Ed Mellinger 831-775-1730 med@mbari.org	MBARI 7700 Sandholdt Road Moss Landing CA 95039 831-775-1700		Schematic, Wind Turbine and Load Sink Interface Board, MOOS Power System	
	Size D	CAGE Code <Cage Code>	DWG NO 1002298	Rev I 7
Wednesday, March 10, 2004	Scale		Sheet 1	of 2

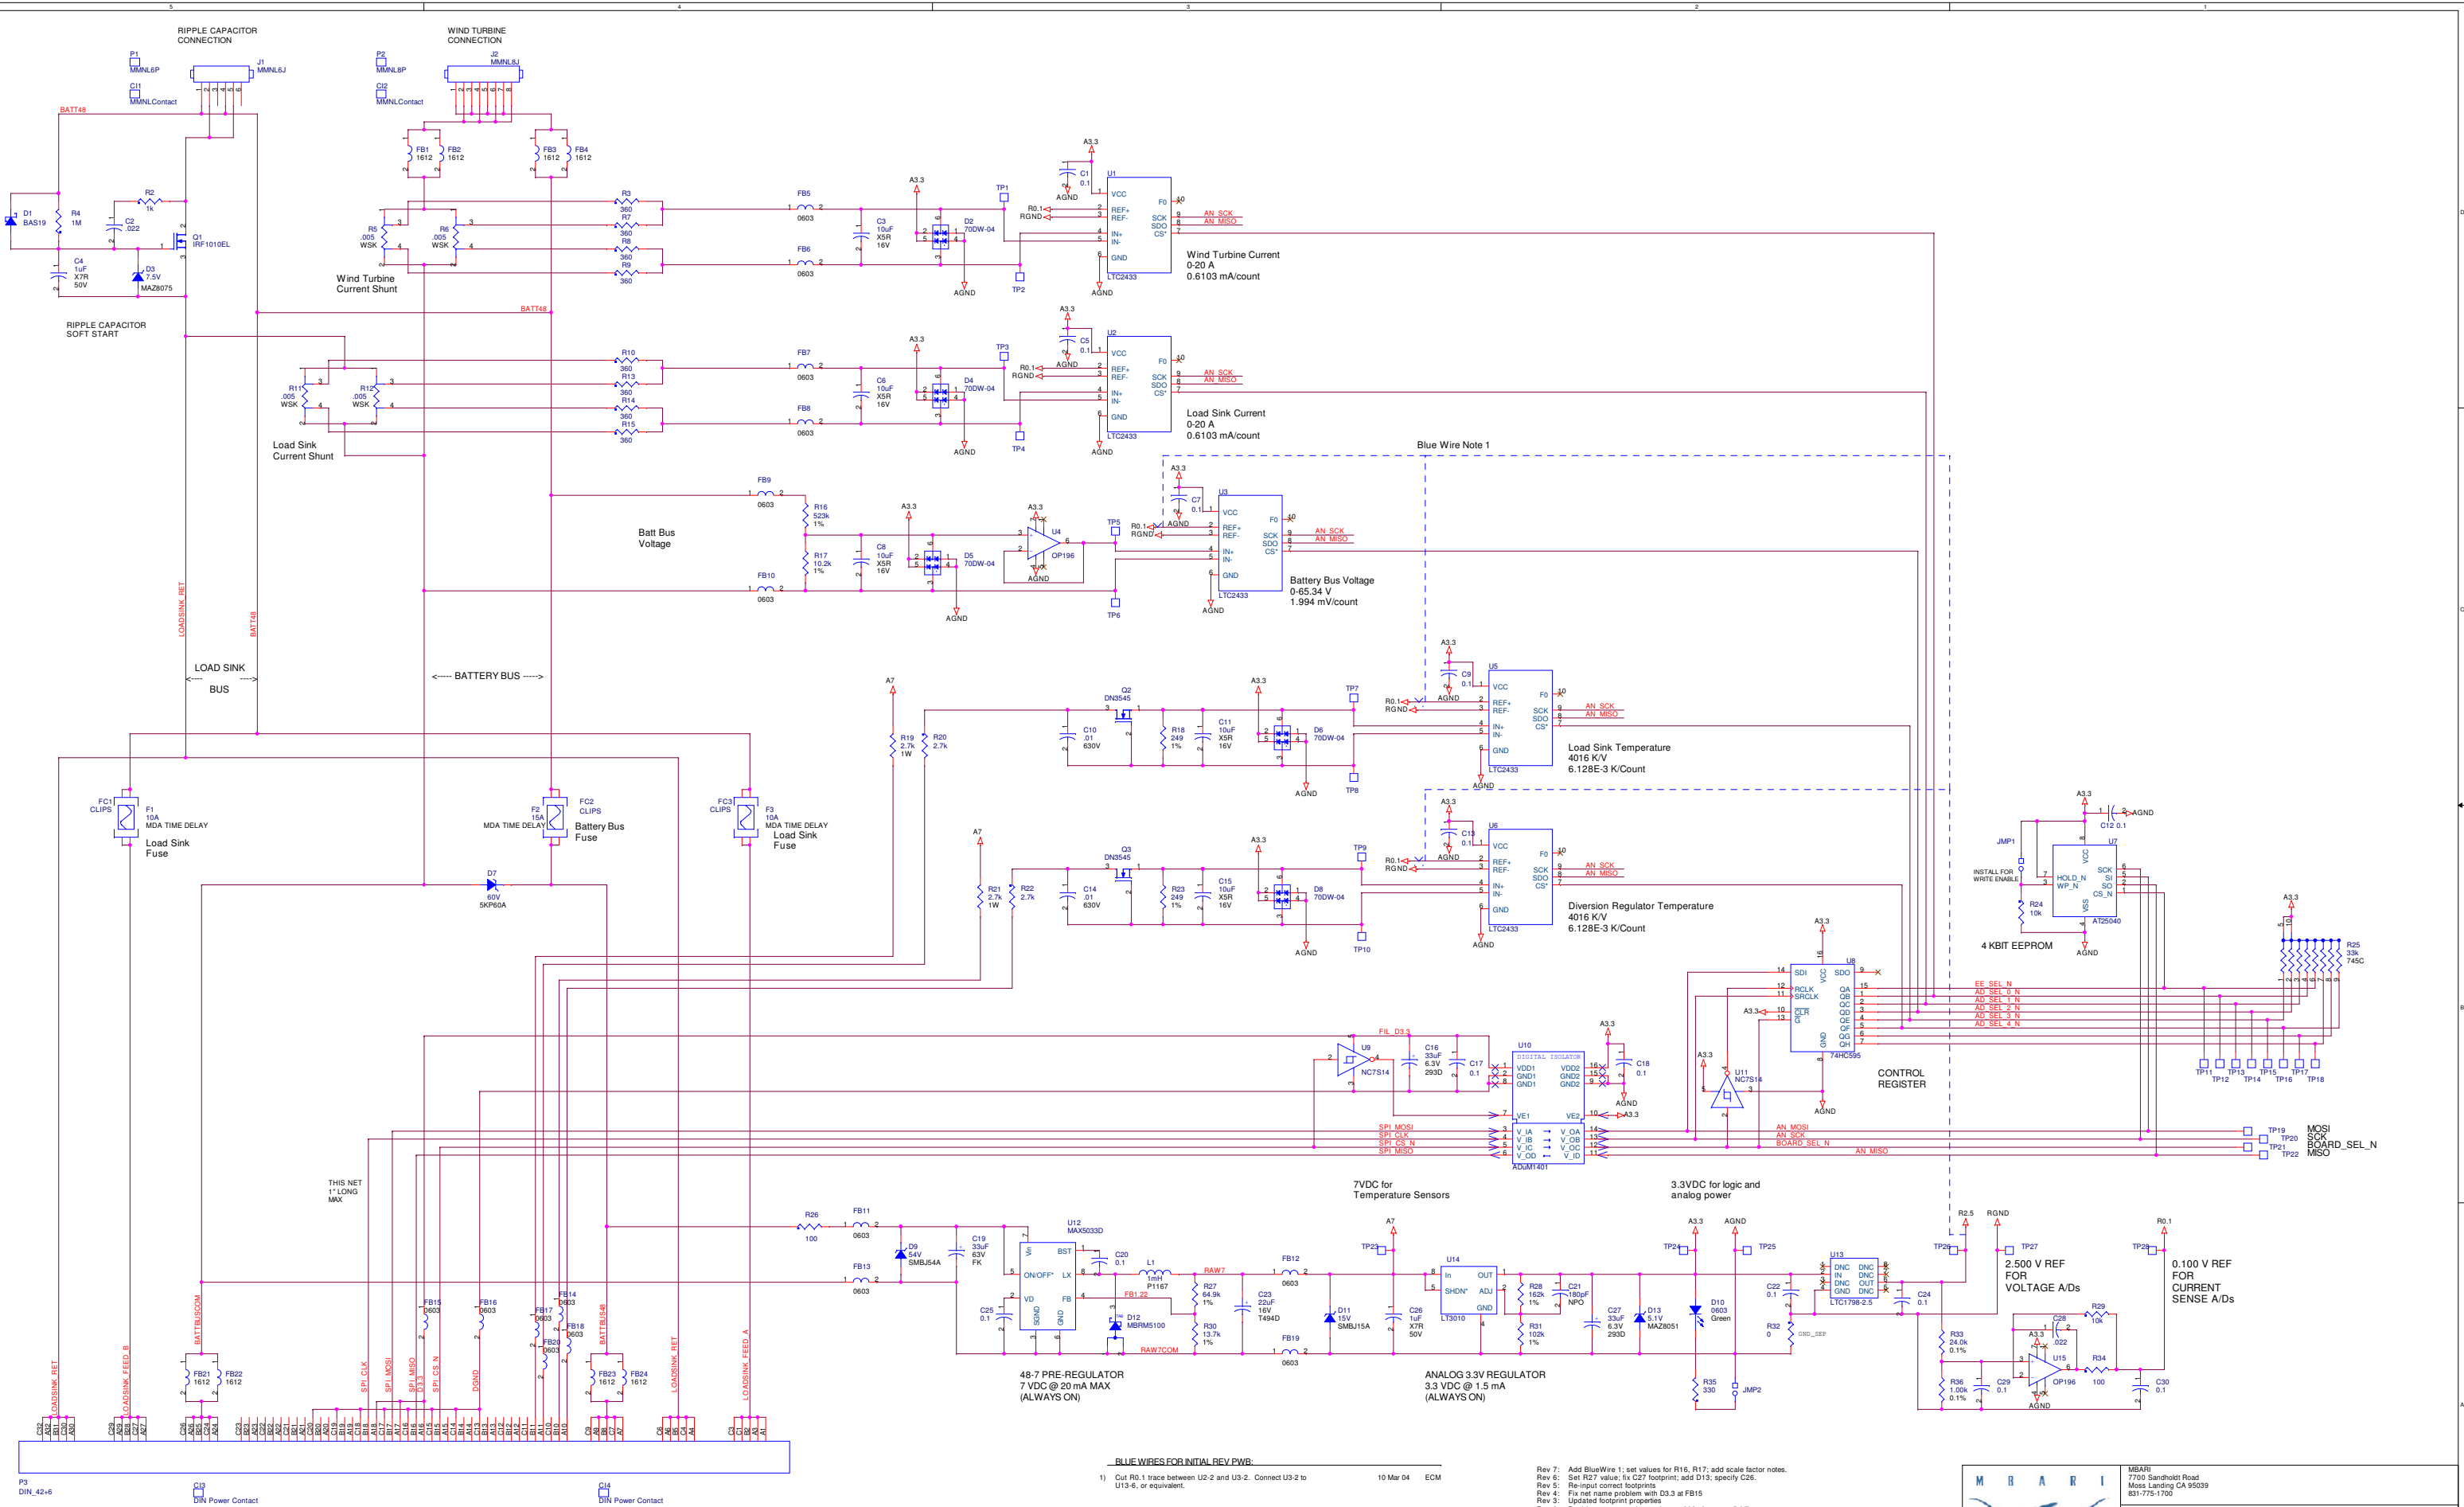
BLUE WIRES FOR INITIAL REV PWB:

- 1) Cut R0.1 trace between U2-2 and U3-2. Connect U3-2 to U13-6, or equivalent.

- Rev 7: Add BlueWire 1; set values for R16, R17; add scale factor notes.
Rev 6: Set R27 value; fix C27 footprint; add D13; specify C26.
Rev 5: Re-input correct footprints
Rev 4: Fix net name problem with D3.3 at FB15
Rev 3: Updated footprint properties
Rev 2: Double-up current shunts due to .002 ohm unavailability.
Rev 1: Initial Release for review
